From: Clark, Mark Steven [msclark0@tva.gov]
Sent: Monday, April 11, 2011 1:28 PM
To: Poole, Justin; Alvarado, Rossnyev
Subject: WINCISE EDCR Excerpts Part 2
Attachments: EDCR 52321-A Excerpts Part 2.pdf

EDCR 52321-A
page 118

System Description Changes to WBN2-94-4003

Figure 8.1
Distribution of Flux Thimbles and Thermocouples

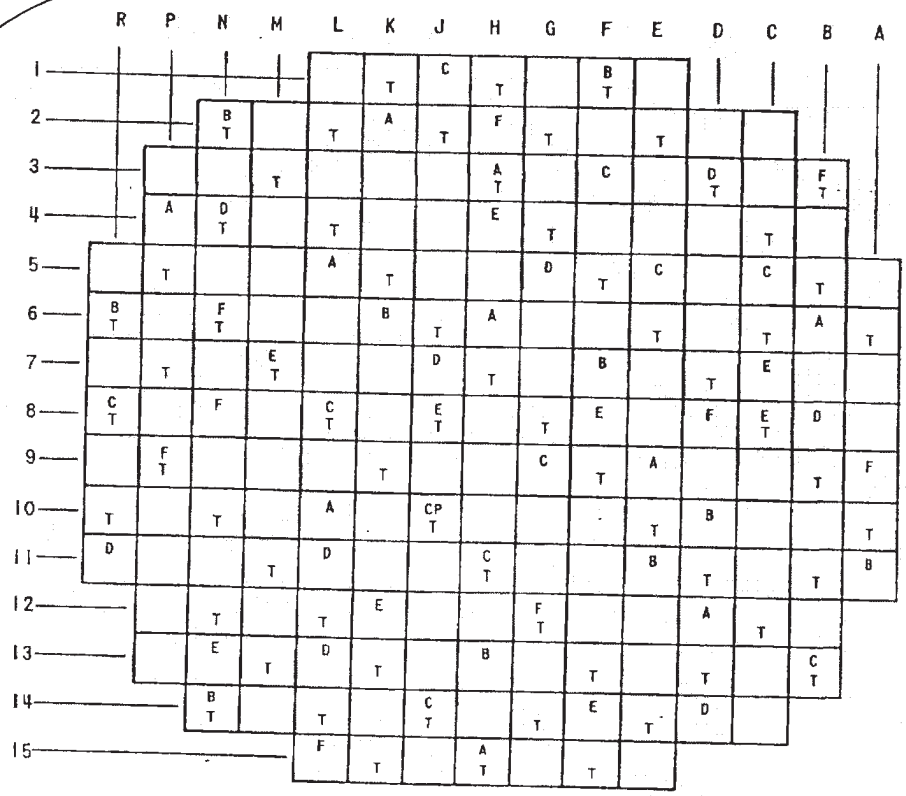
8.1 Distribution of ~~Flux Thimbles and Thermocouples~~ IITAs

Replace with figure from following page

Figure 8.2 IITA General Arrangement

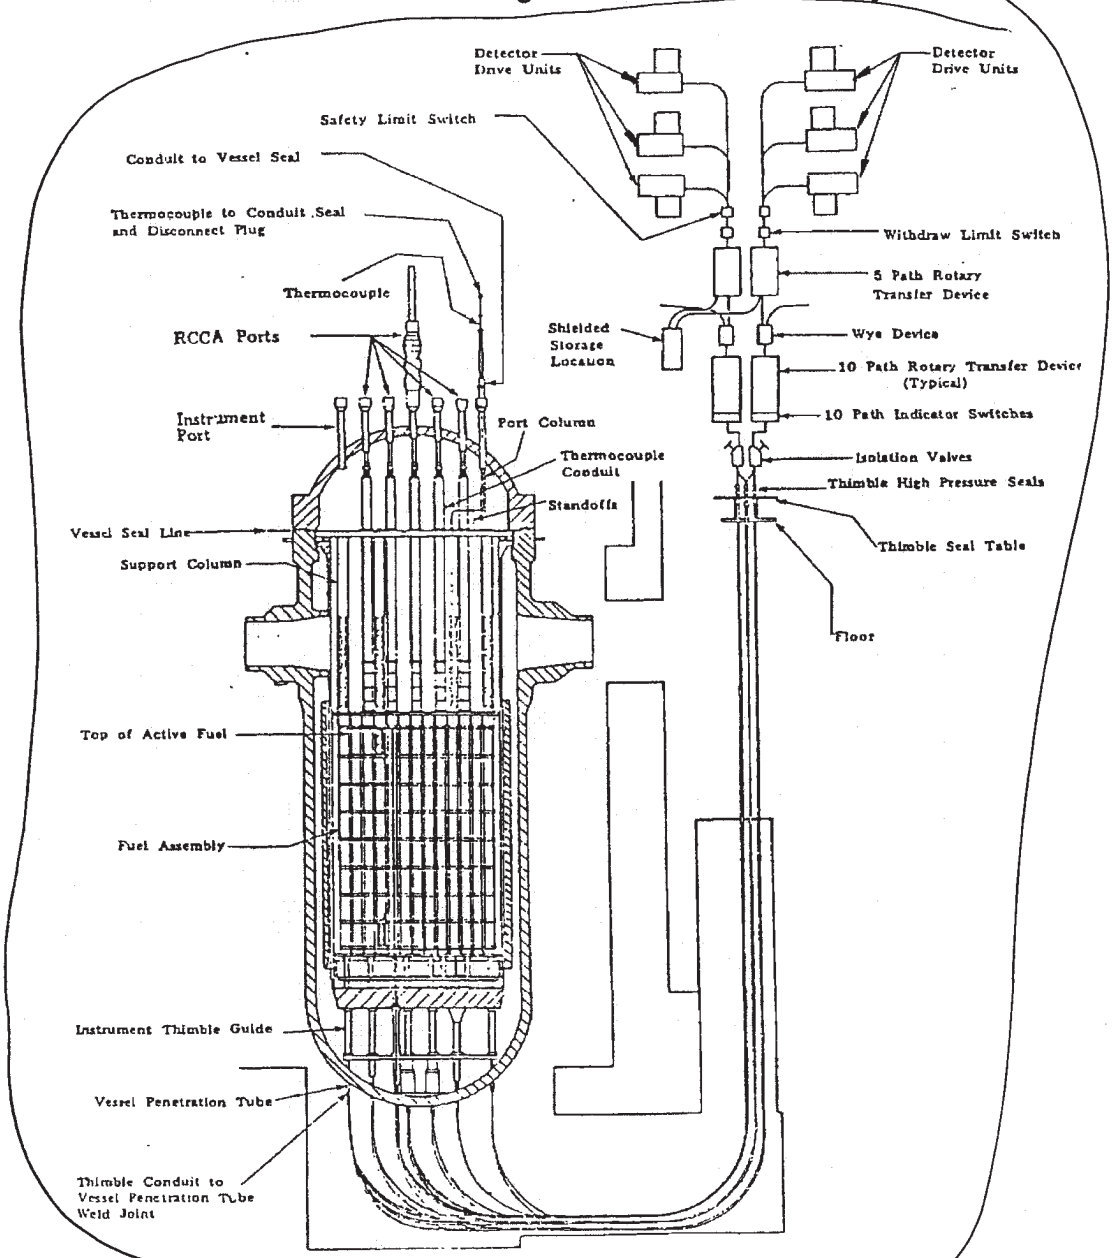
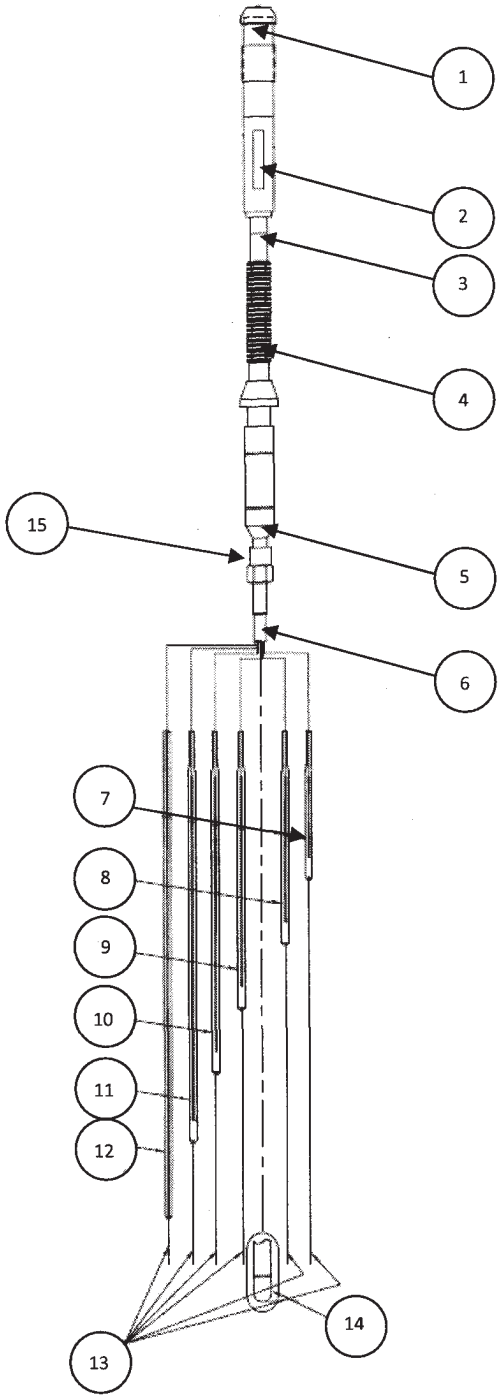
8.2 ~~Reactor Vessel Cross-Section Showing Incore Instrumentation System~~ ~~System Classification in Containment~~ ITA general Arrangement

Replace with figure in following page

Figure 8.3
Pictorial View of the Incore
Neutron Flux Detector Insertion System

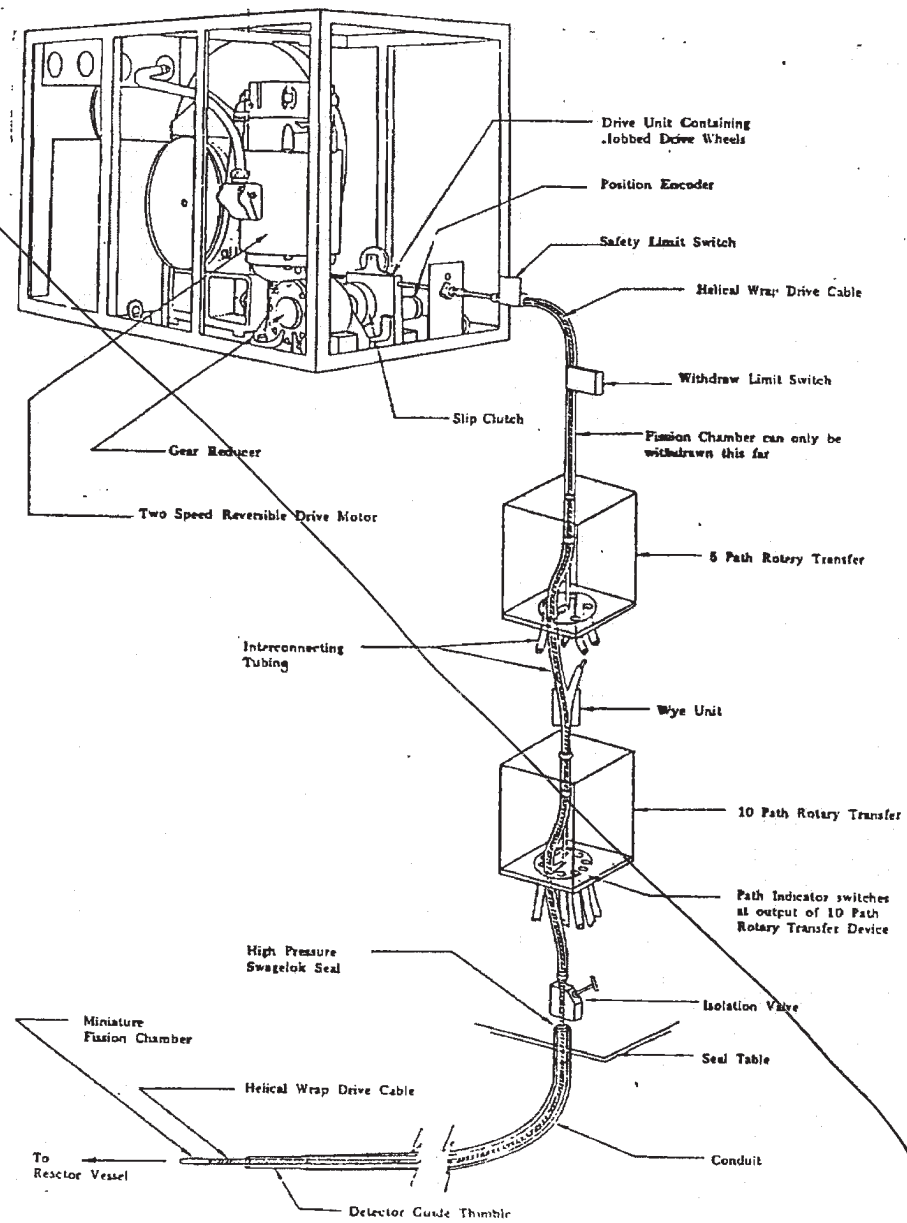
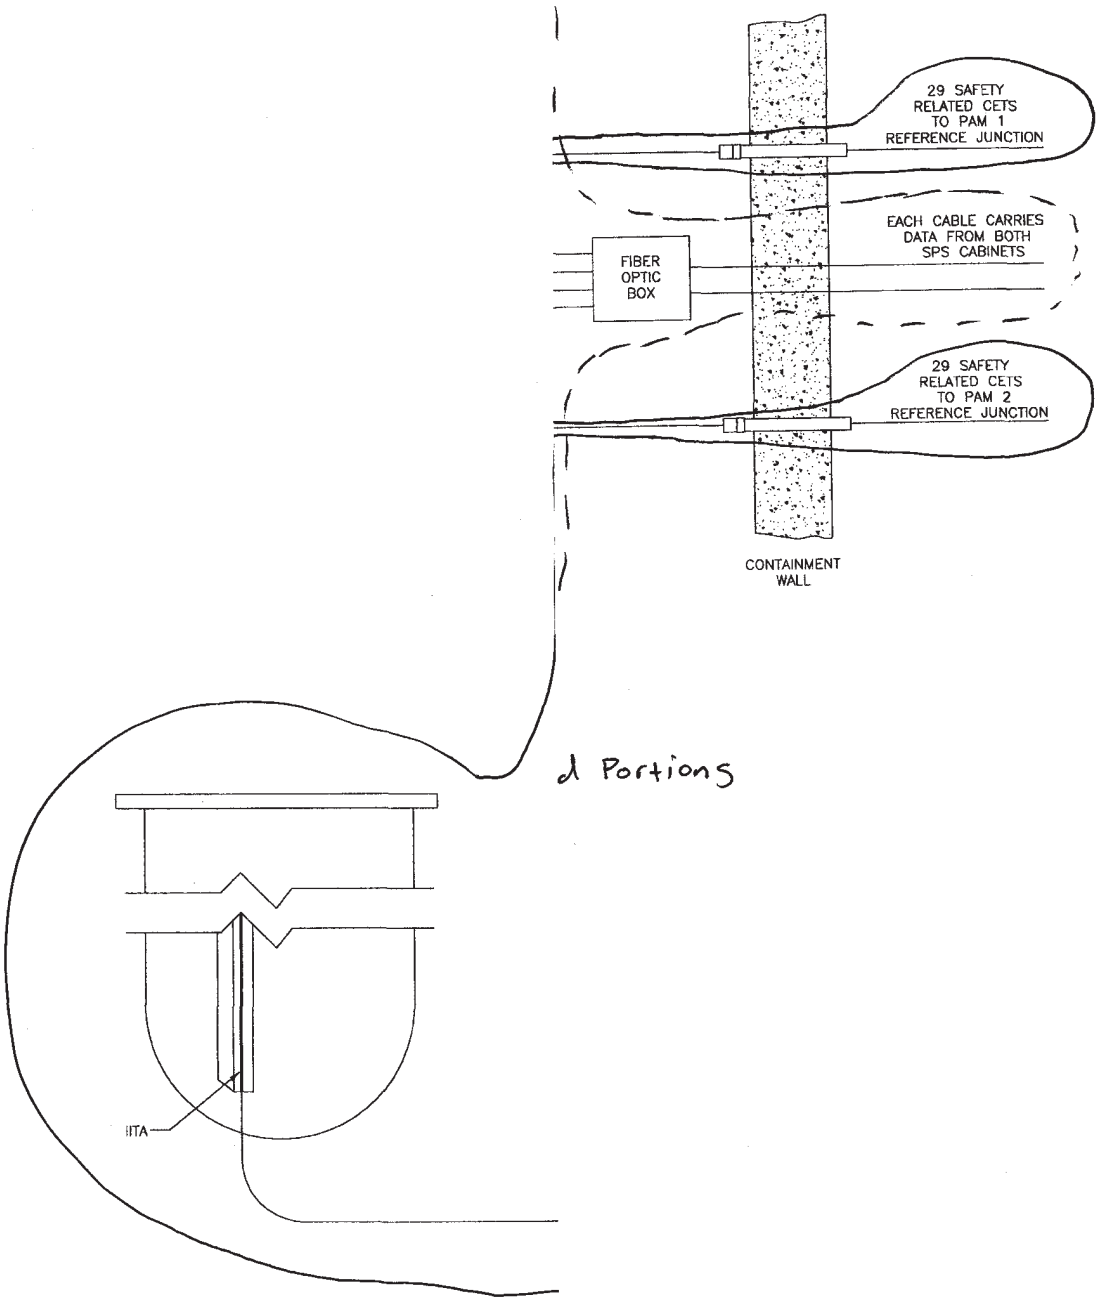
~~8.3 Pictorial View of the Incore Neutron Flux Detector Insertion System~~

Replace with following page

Figure 8.4
Incore Flux Detector Insertion System

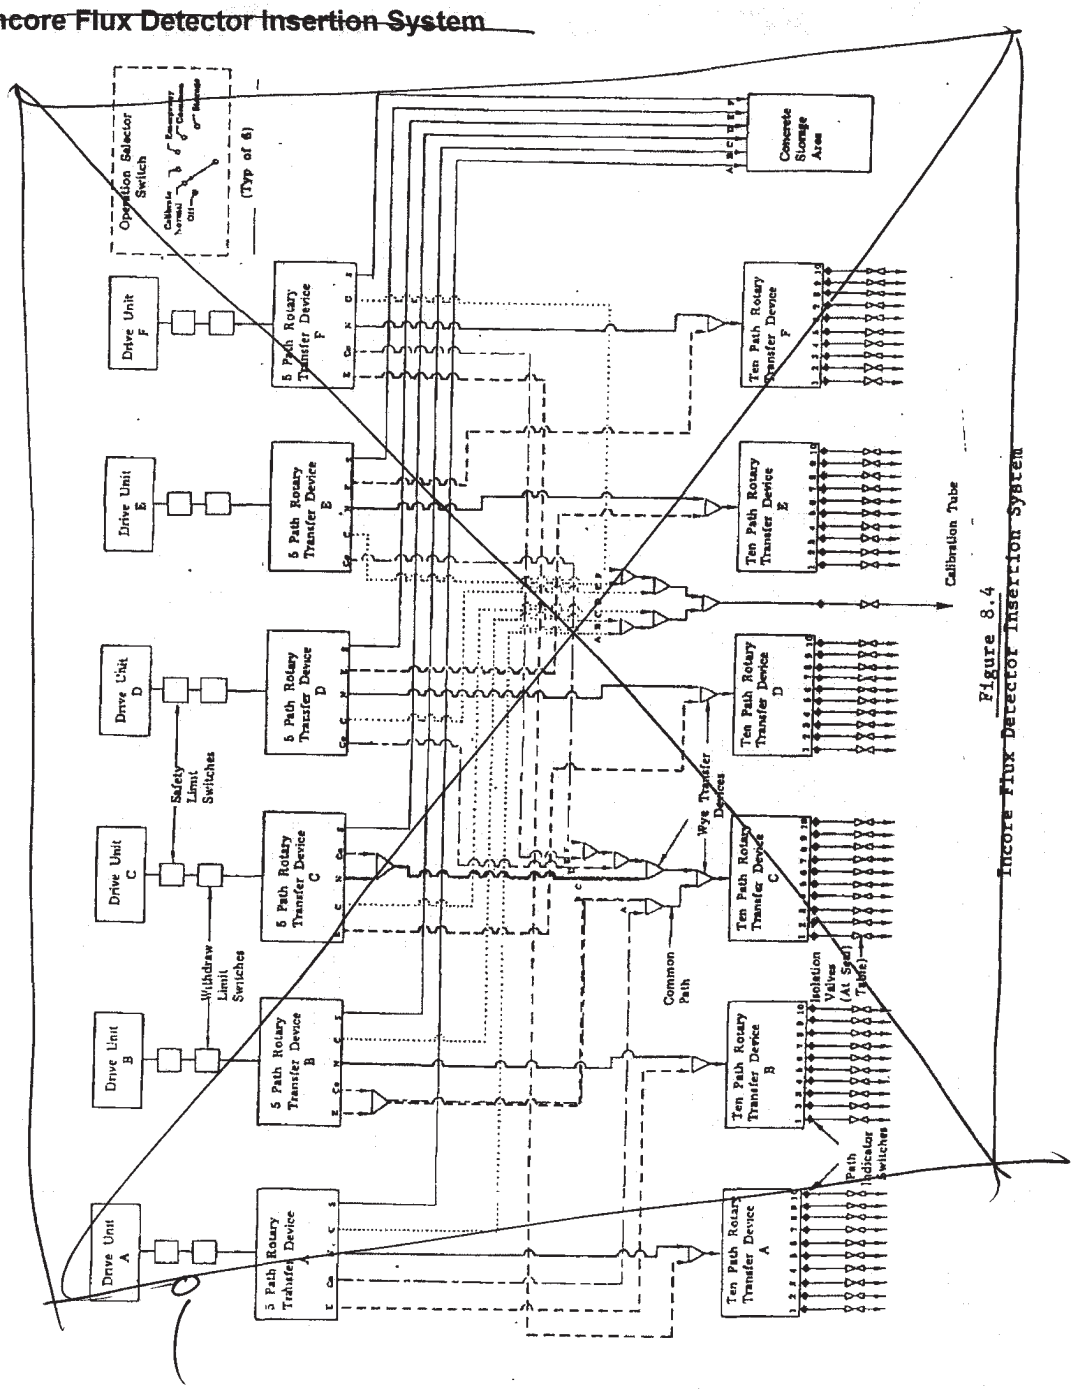
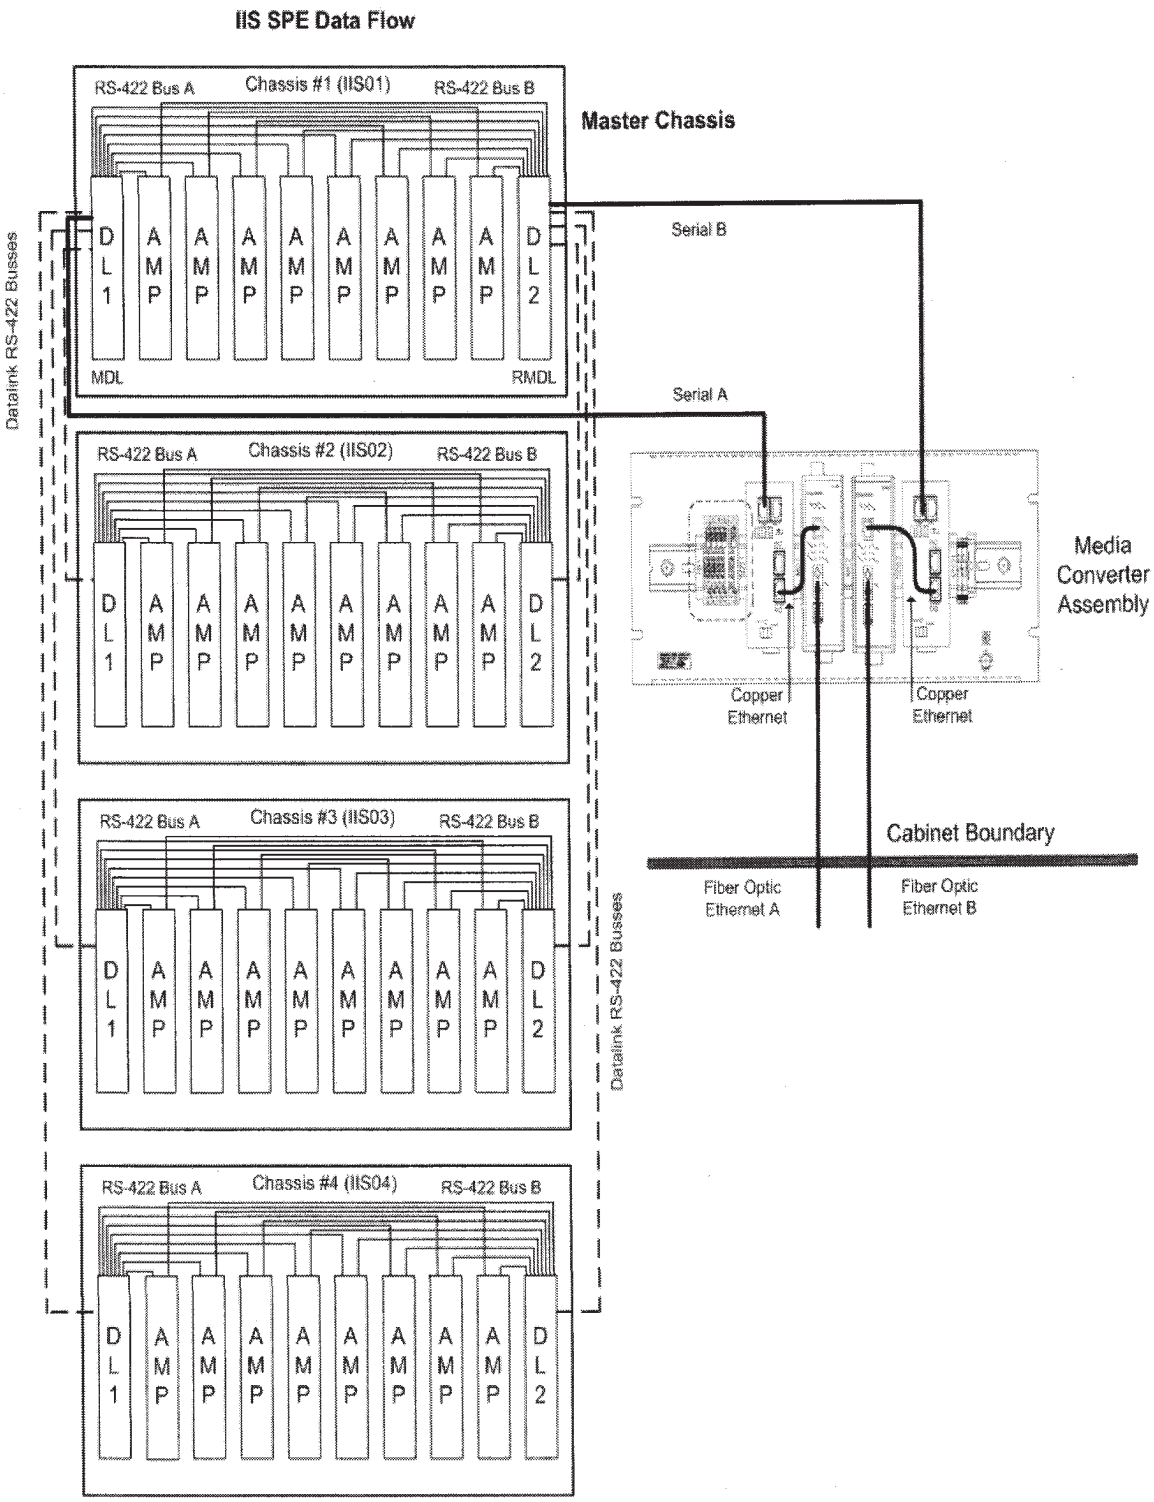
~~8.4 Incore Flux Detector Insertion System~~

Replace with following figure

Figure 8.4 - SPS Cabinet Data Flow

Westinghouse Electric Company	*CET MI Cable Layout*	Figure 8.5

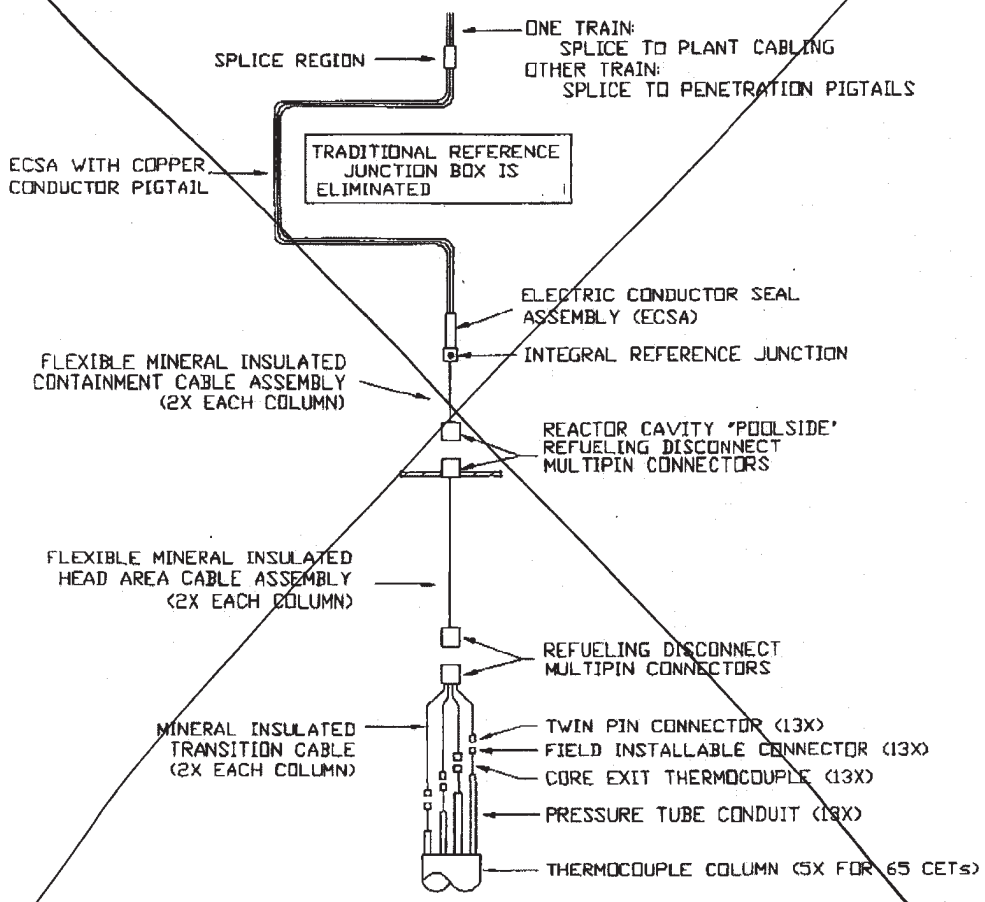
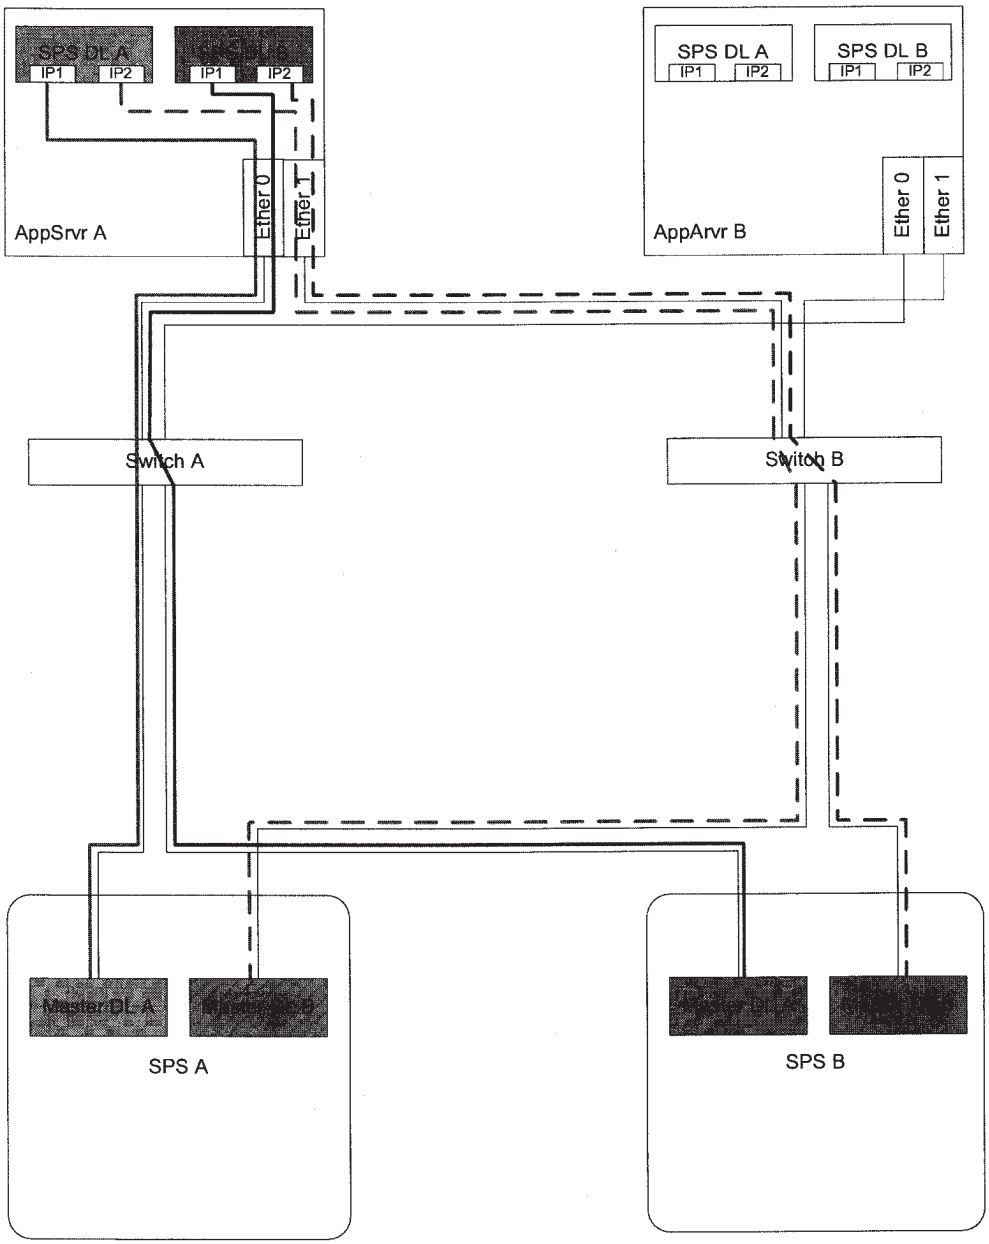
Replace with following figure

Figure 8.5 – SPS and App Server A Configuration

Failure of switch A will dictate the alternate (dashed) paths be used.
